BENZIE-LEELANAU DISTRICT HEALTH DEPARTMENT APPEALS BOARD MEETING AGENDA Wednesday, November 5, 2025 – 11:00 AM

Staff Report

Appeal # L25-001
Betsey Davis (Applicant)

Subject Location:
1425 S. Nanagosa Trl.
Suttons Bay, MI 49682
Parcel ID: 45-011-460-049-01

Site Plan - Davis Culvert

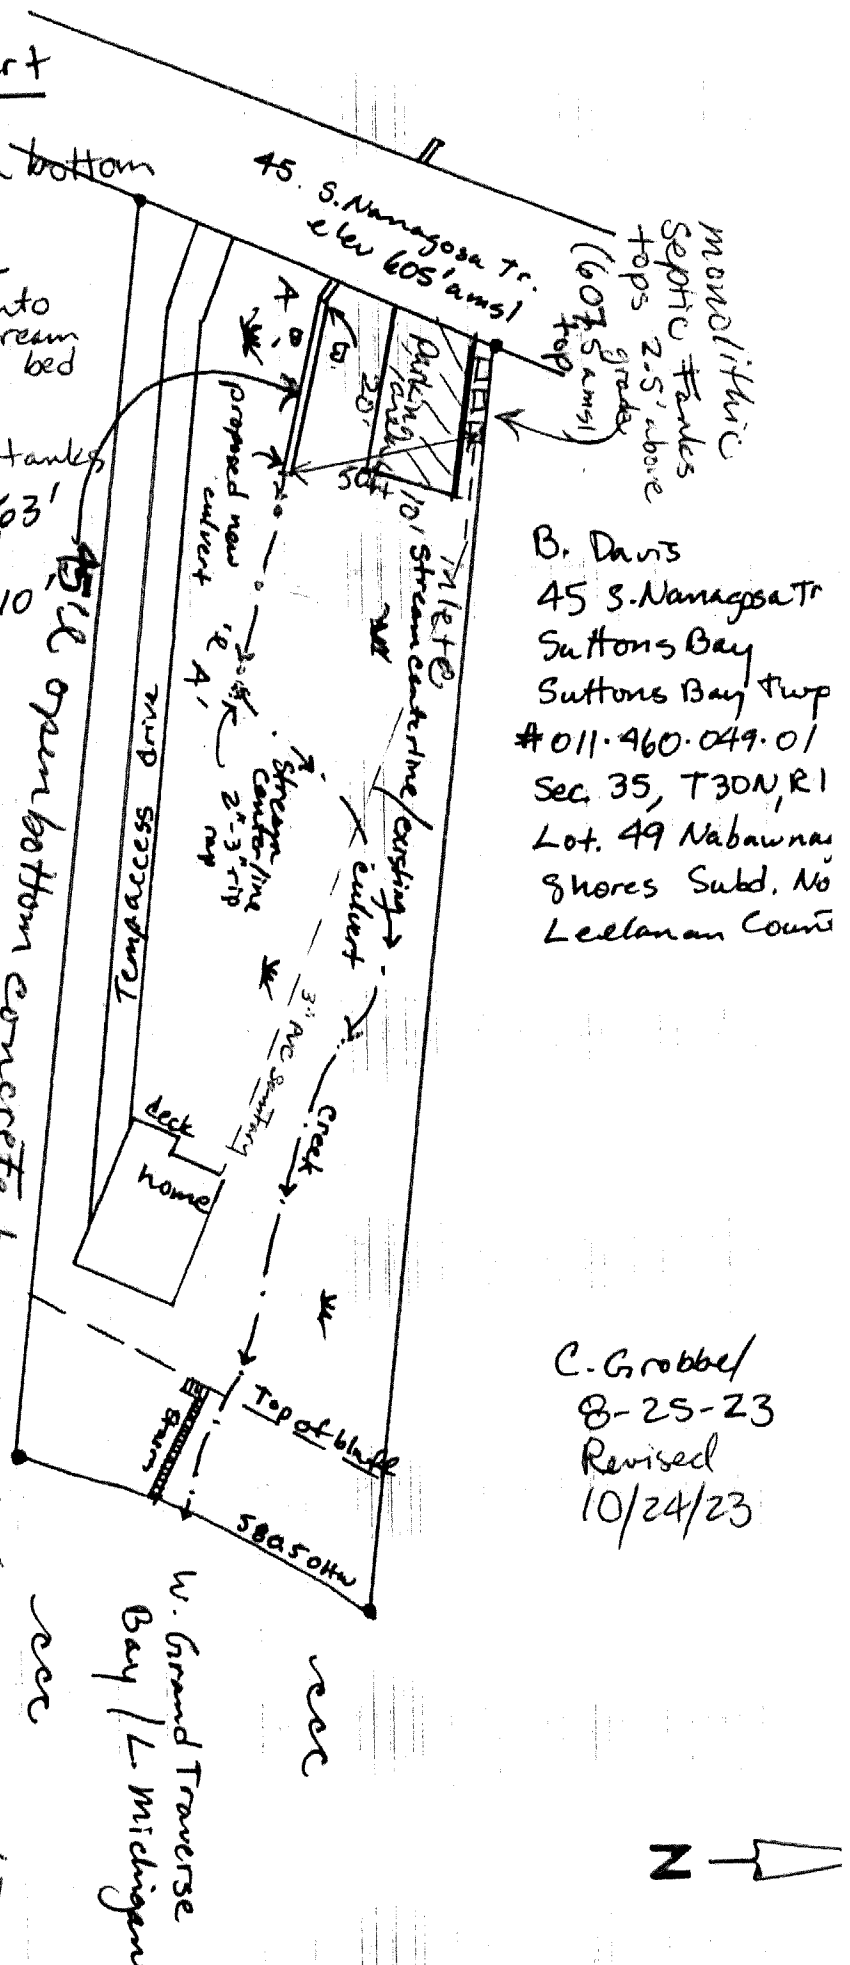
The project plans also reflect a proposal to install riprap in the stream and wetland. Please update the application.

Please provide verification from the Benzie-Leelanau District Health Department that the septic tanks can be placed immediately along the property line, vs. the typical required 10ft. setback.

Riprap has been removed from the project. See revised site plans & cross-sections dated 10/24/23.

See revised attached X-sections B-B' 10/24/23.

SITE PLAN

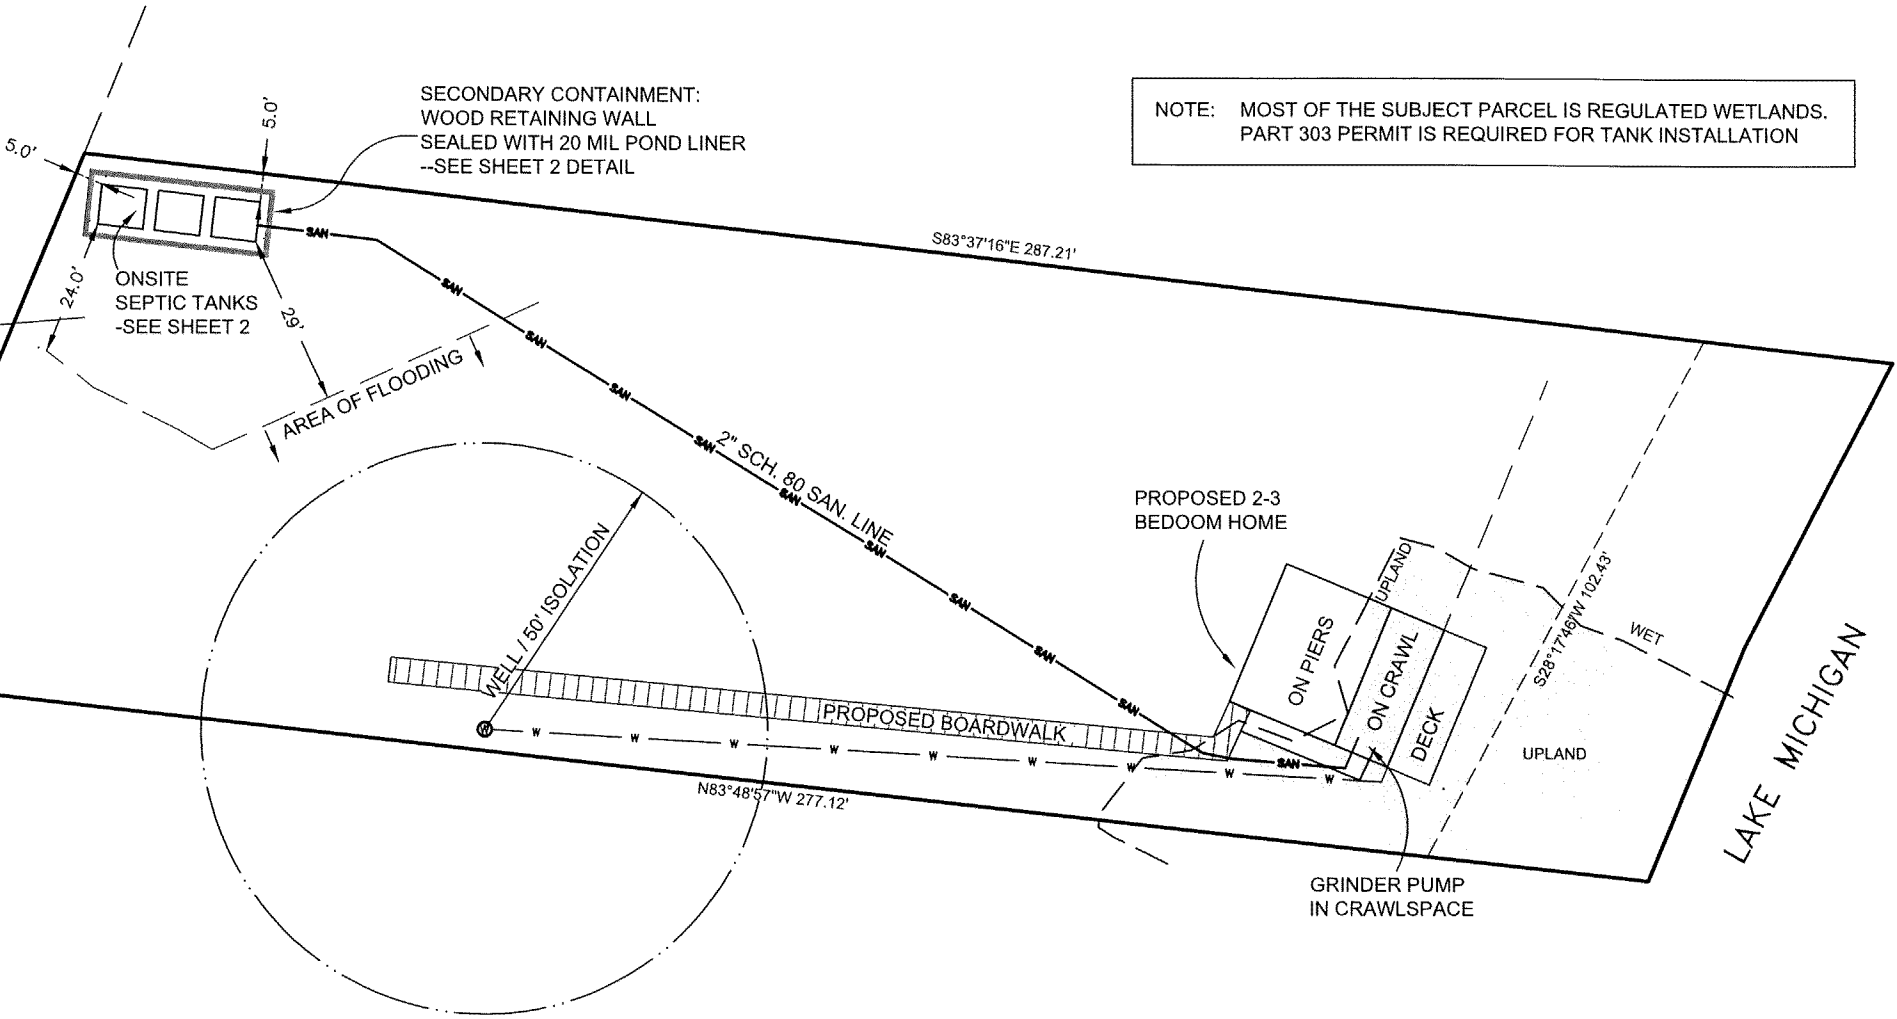
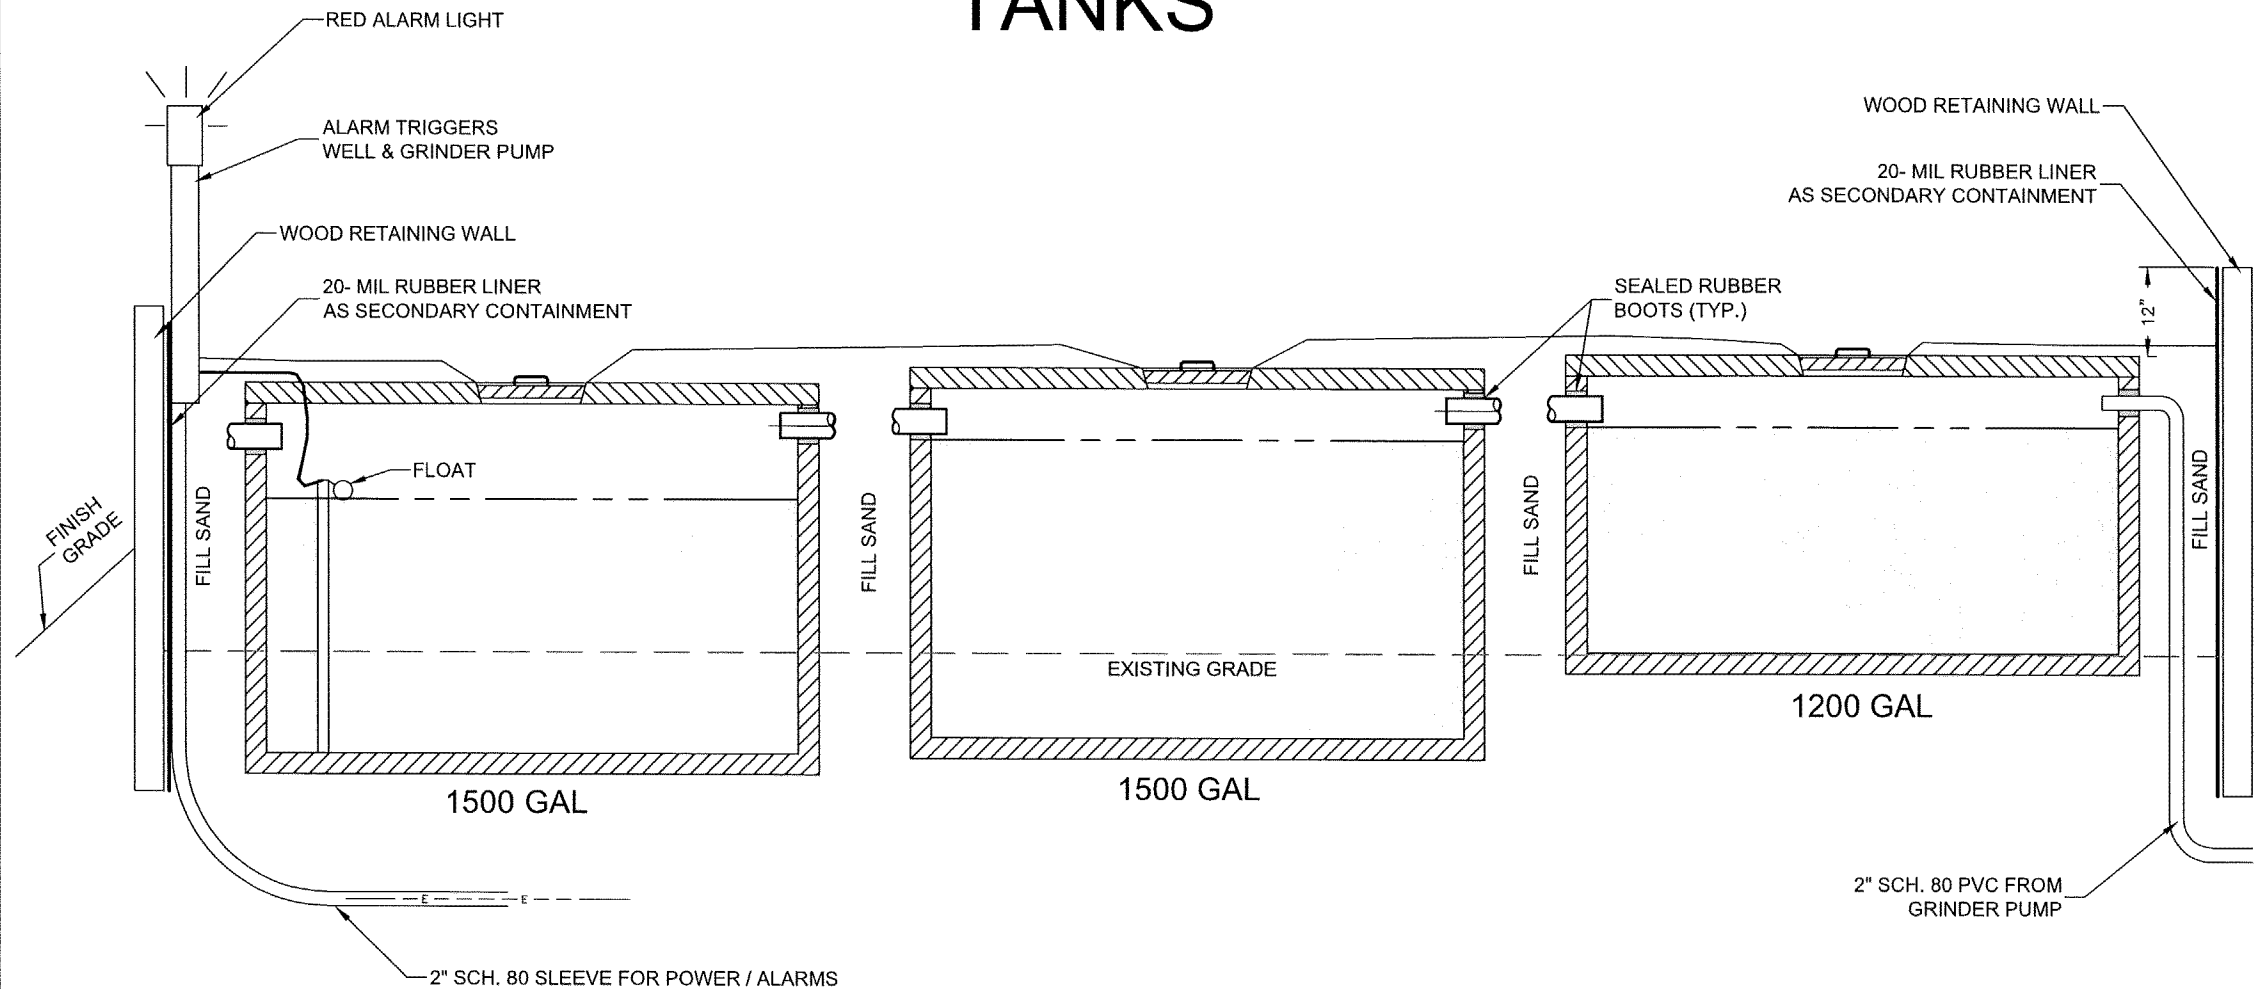
During the on-site evaluation, no area was identified that could meet the minimum required isolation distance from surface water or the necessary soil conditions for wastewater absorption and treatment.

The Benzie-Leelanau District Sanitary Code, Sections 3.8.2(a)(2) and 3.8.5(a)(2), requires that any sewage disposal system, including both conventional systems (septic tank and drainbed) and holding tank systems, be isolated a minimum of 50 feet from surface water.

- Due to the stream's presence and meandering path across the property, no portion of the parcel provides a 50-foot separation between potential sewage system components and surface water.
- The poorly drained soils and wetland conditions further prevent adequate treatment and dispersion of wastewater.
- Even a holding tank system cannot meet the required 50-foot isolation distance.

As a result, the property cannot support an on-site sewage disposal system of any type, and the Health Department is therefore unable to issue a sewage disposal permit for the proposed development.

The proposed Site plan details the minimal system required for homesite in Leelanau County. The system would comprise of a grinder pump installed in the crawl space of the home. A 2" Sch 80 pressure sewer, at minimal depth of 8' under the wetland would be installed by directional bore to the 1 st tank in a series of 3. The 3 tanks would work in harmony with an alarm set on the 3rd tank. The alarm would be set so if it went off, it would trigger the water well and grinder pump breakers and reduce risk of overflow. The grinder pump in a crawl space does NOT have a 50 foot isolation from standing water or flooding because the code considered the secondary containment of the crawl space to waive that requirement. The proposed tank cluster

would consist of mono poured tanks, so there are no seams. Additionally, the tanks have pre-motored rubber boots on the inlet and outlet to prevent leaking at the outlets. The tank cluster also has a proposed secondary containment system, detailed on the Siteplan. This secondary containment system consists of a wood retaining wall and a 20 mil rubber liner. If any effluent were to leak or get spilled the rubber liner would contain the overflow until which time a pump truck could vacuum out the spilled effluent. The most likely spill or overflow situation that can occur is septic truck mal-function, and the effluent back flowing from truck to site. The secondary containment wall would hold the volume, giving the operator time to correct the error before reaching the creek.

The variance or waiver to BLDHD code that is being requested was detailed on Reardon letter dated September 8, 2025. The 50 foot isolation from surface water or highest flood elevation is the major variance, (requested reduction to 24'). We have also requested a variance waiver for the isolation of the tank cluster to the property line, reduced to 5'(code requires 10').
